Field Modification Tracking Table

Field Modification / Construction Bulletin Form	Date (dd/mm/yyyy):	07/31/12
Lower Passaic River Project, Phase I Removal	FM # or CB # (FM - ### or CB - ###):	CB-001
ARCADIS	Revision (##):	0

Lower Passaic River Project

TIERRA SOLUTIONS, INC. • LOWER PASSAIC RIVER, NEWARK NJ
PHASE I CERCLA NON-TIME-CRITICAL REMOVAL ACTION
OU-1 FLOODWALL TIEBACKS WALE MODIFICATIONS - (1 OF 3)

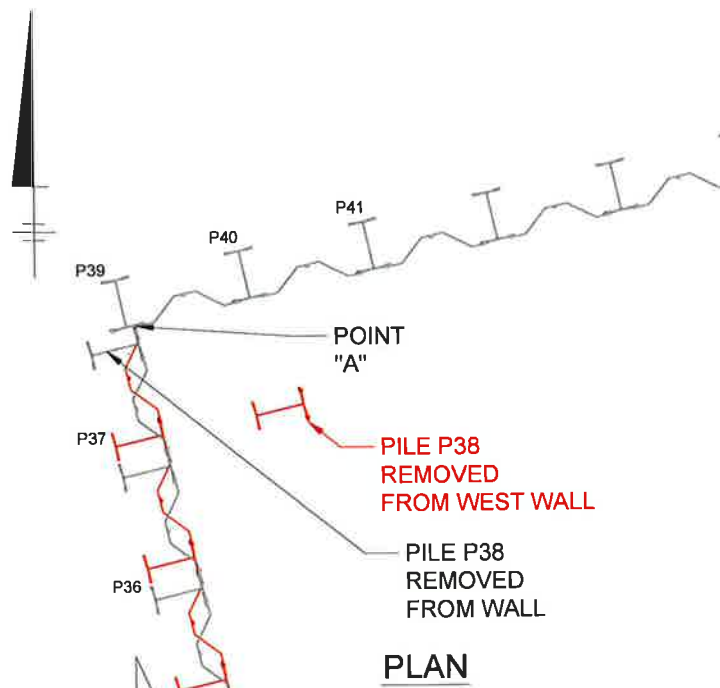
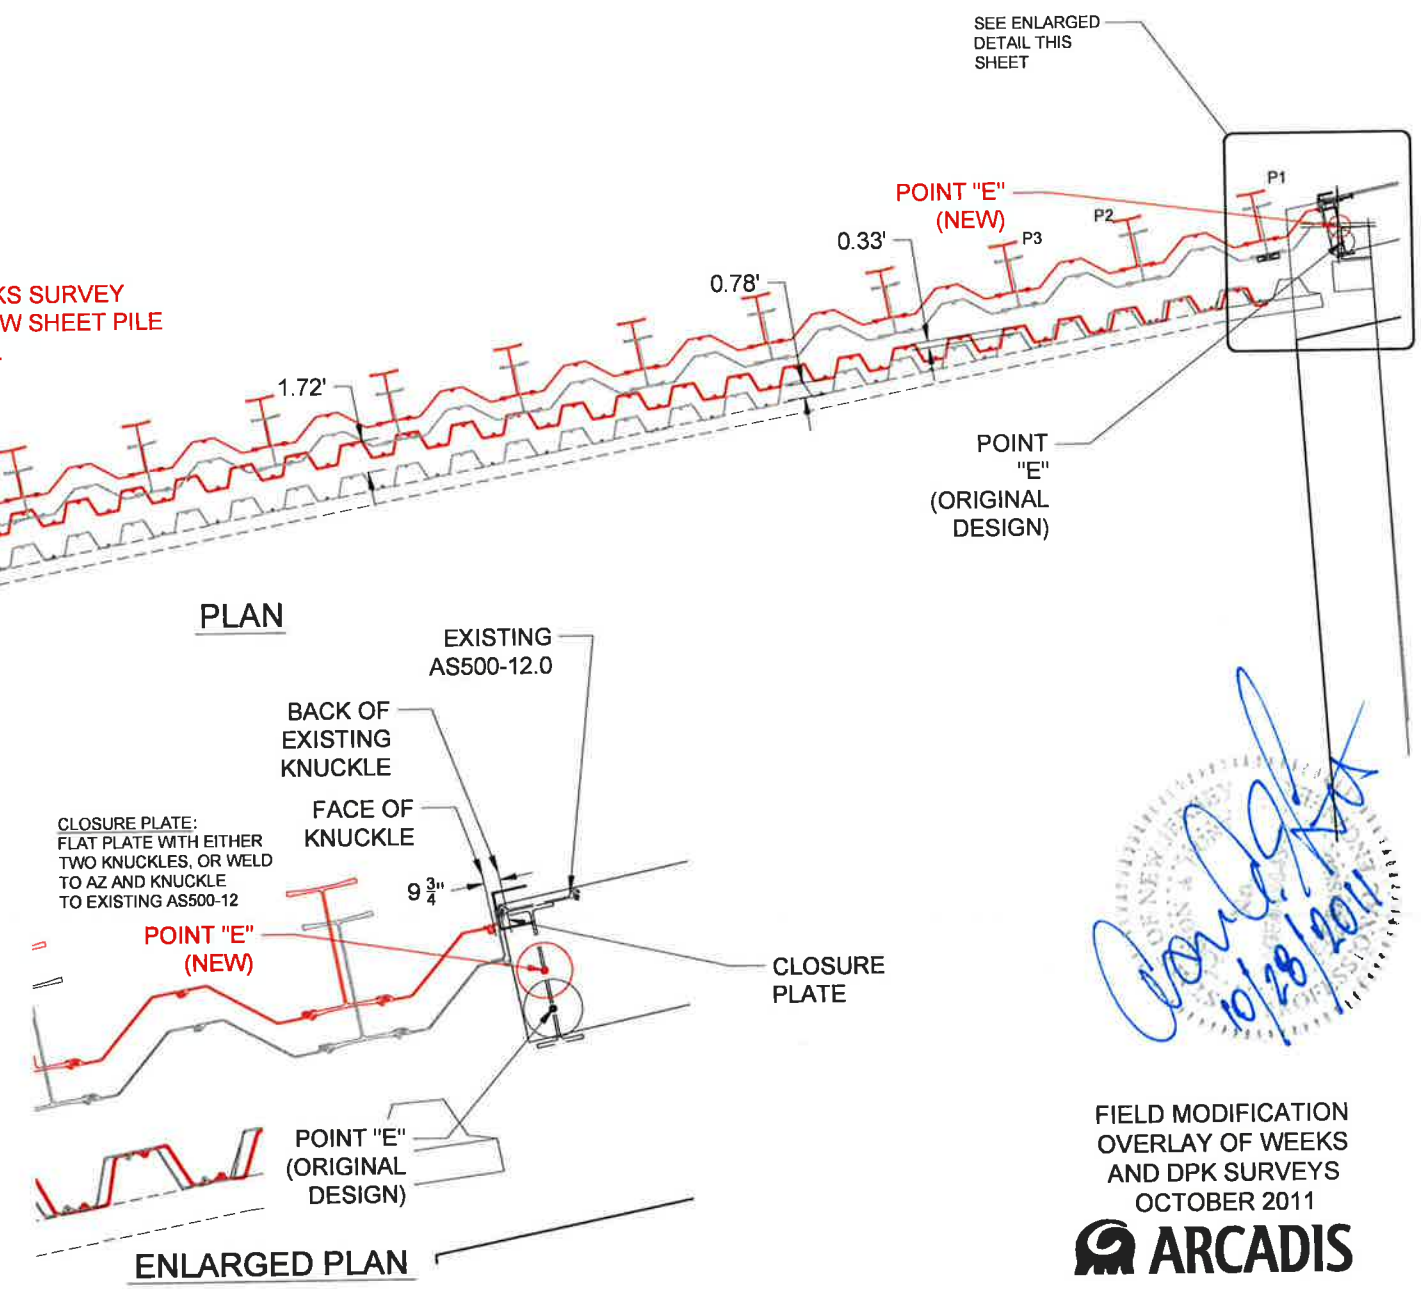
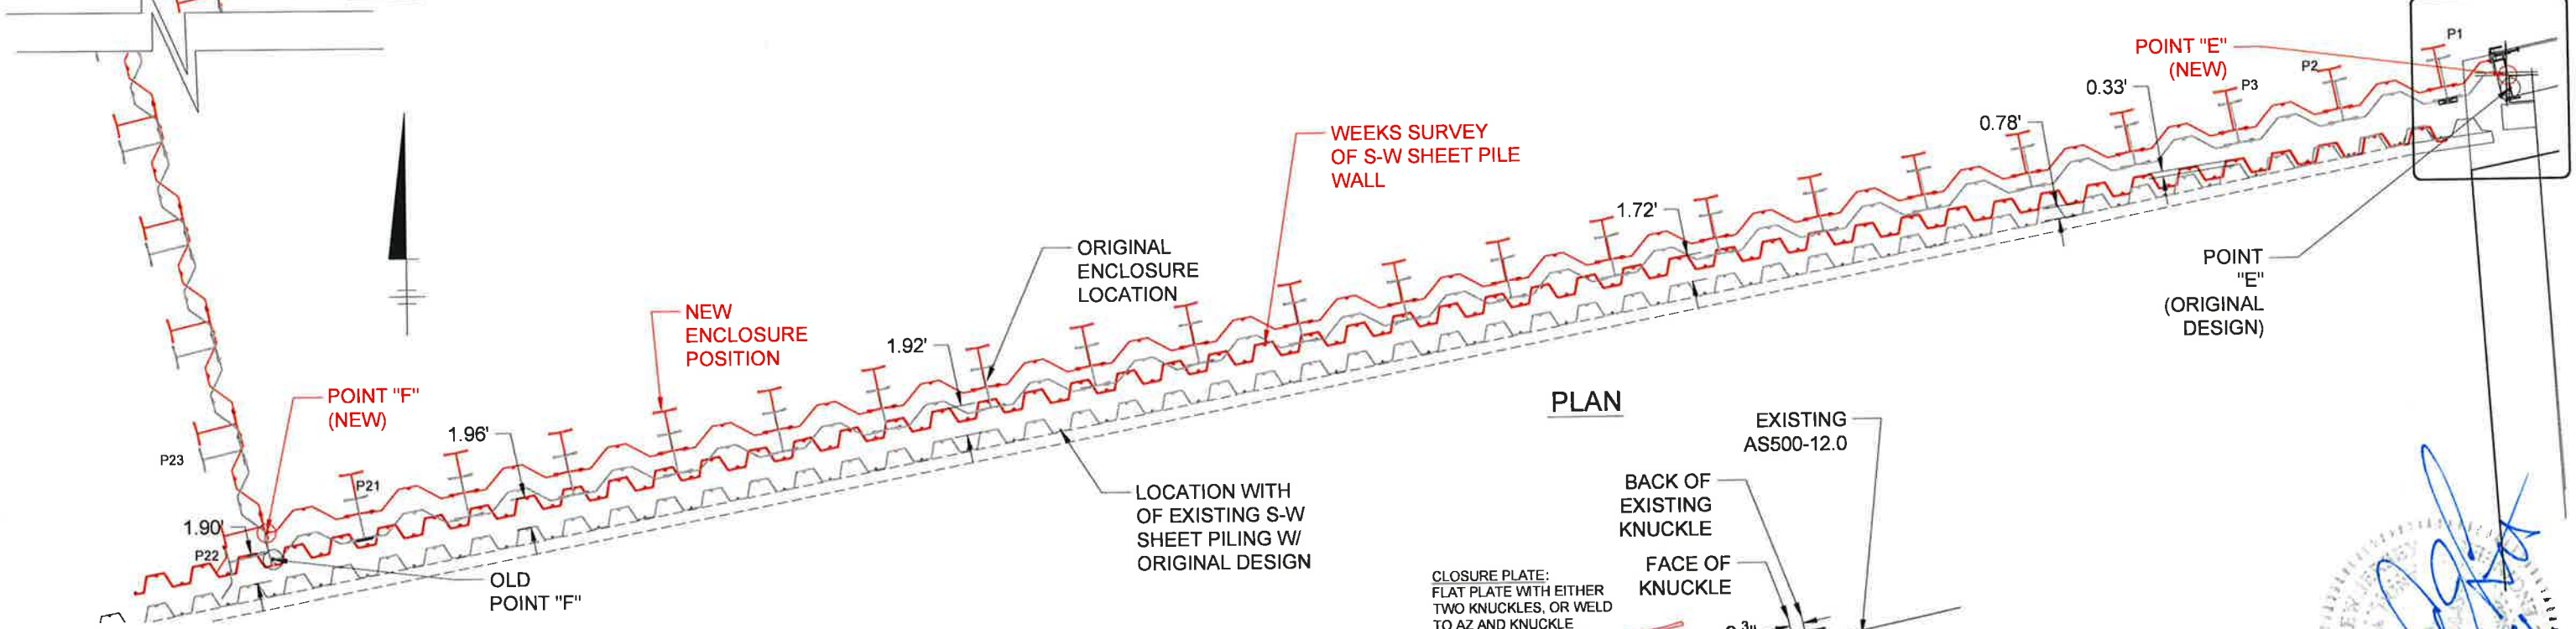
During field survey of the proposed S-W enclosure wall alignment, it was determined that the existing S-W sheet pile wall would interfere with enclosure alignment. This was due to inaccuracy in the existing DPK survey information for the alignment of the existing S-W sheet pile wall. In order to install the S-W enclosure wall outboard of the existing S-W sheet pile wall, survey control points E and F (Drawing G-4) were adjusted. To accomplish the revised positioning, King Pile P-38 was removed from the west enclosure wall, and King Pile P-1 was adjusted approximately nine inches north into the Passaic River. These changes resulted in a change to the S-W enclosure wall alignment. The old and revised S-W enclosure wall alignment and old and revised survey information of the S-W sheet pile wall are provided as an attachment to this field modification along with the plan views showing the elimination of P-38 and adjustment to the OU-1/S-W enclosure wall connection (Detail 6 on S-4). The revised alignment was positioned to minimize change to the Phase I footprint and removal volume.

<u>Design Coordination and Documentation</u>		Date
Are sketches detailing design modifications attached to FM?	Yes / No	<input type="text" value="10/28/11"/>
Are existing drawings required to be updated, sealed and re-issued? <small>(note - as-built drawings will be issued after construction and will incorporate FM)</small>	Yes / No	<input type="text"/>
Do the specifications need to be modified?	Yes / No	<input type="text"/>
Specific drawings and/or specification sections and paragraphs affected: Drawings G-4, S-2, S-3, S-4 (Details 4 and 6)

1 SE CORNER JAN-24-2012

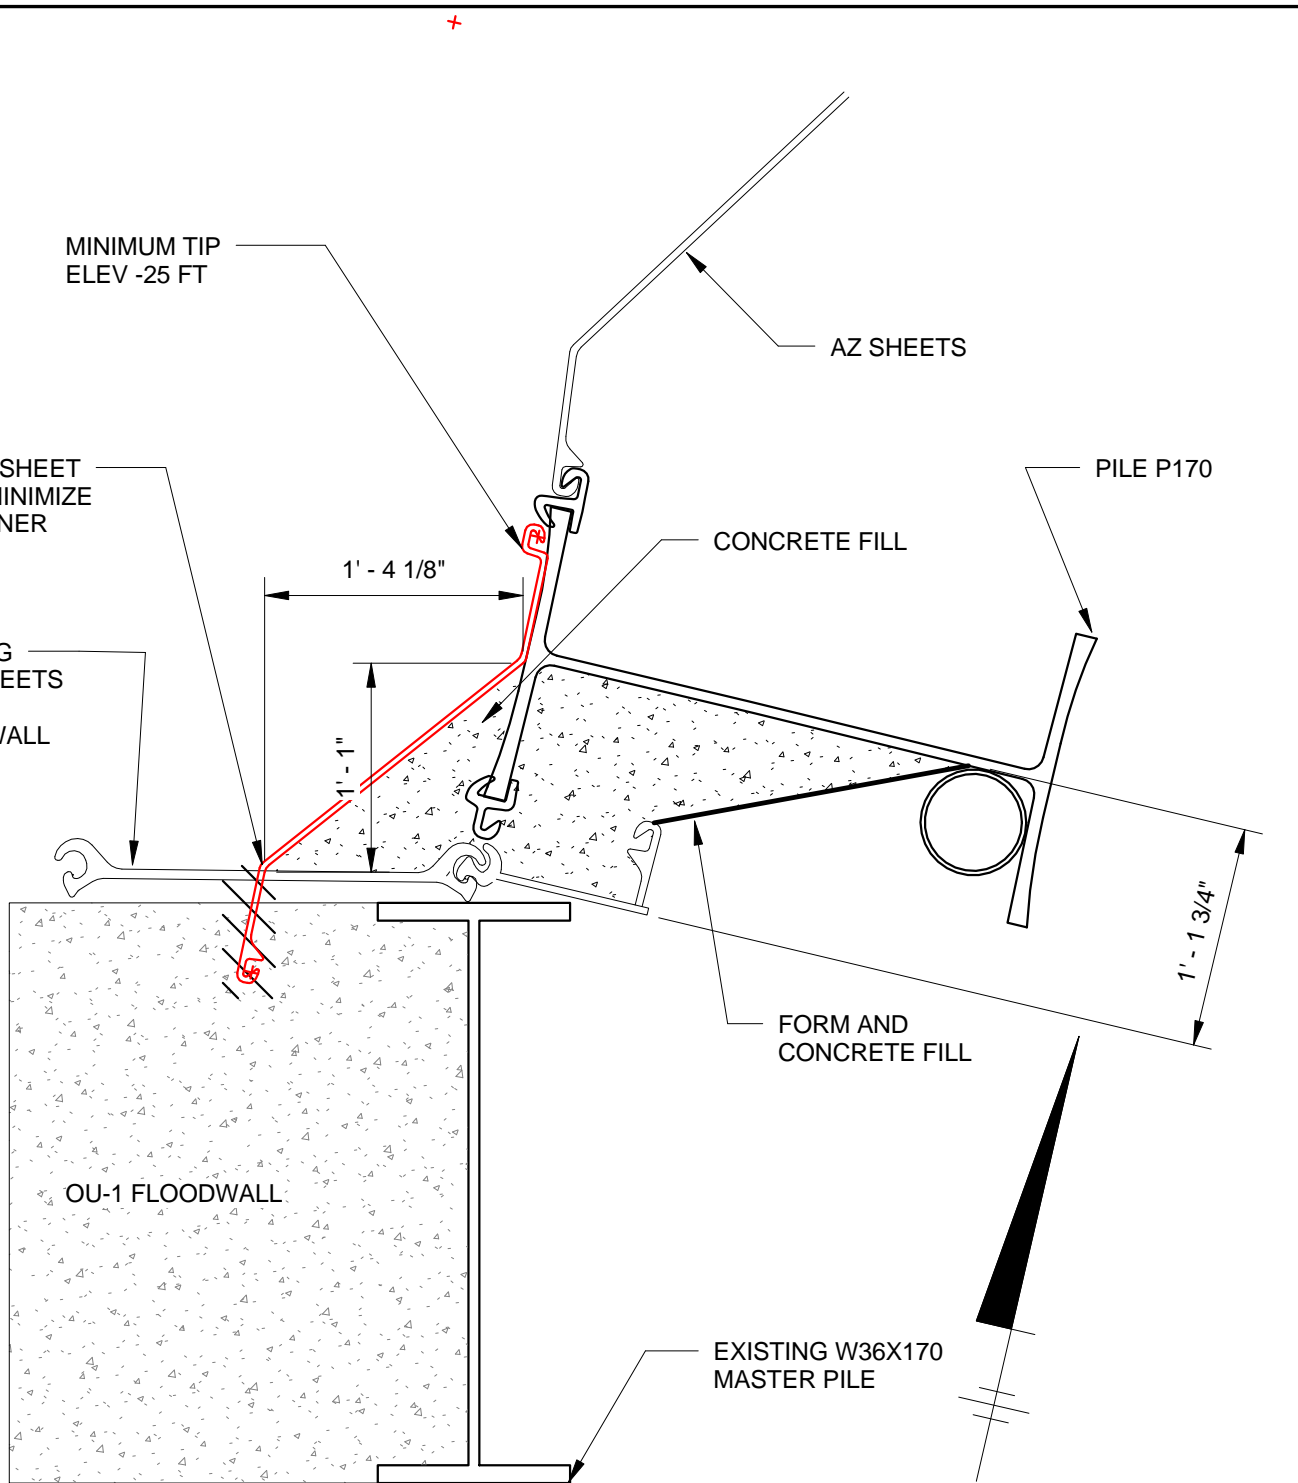
As-built position of P170 (the king pile nearest to the SE corner of the enclosure at the OU-1 floodwall), has slightly shifted south creating a geometry that makes the designed junction pile connecting the enclosure and OU-1 no longer workable. This junction pile at the SE corner is shown on S-6, Detail 3 and enlargement interlock detail. This junction pile included a pipe section welded as part of the individual sheet pile to increase deflection capacity at this location (the pile was to be field measured prior to fabrication by Skyline/L&L). The field modification includes a revised geometry for the junction pile and inclusion of CDF grout to make the SE corner water tight as shown in the attached detail.
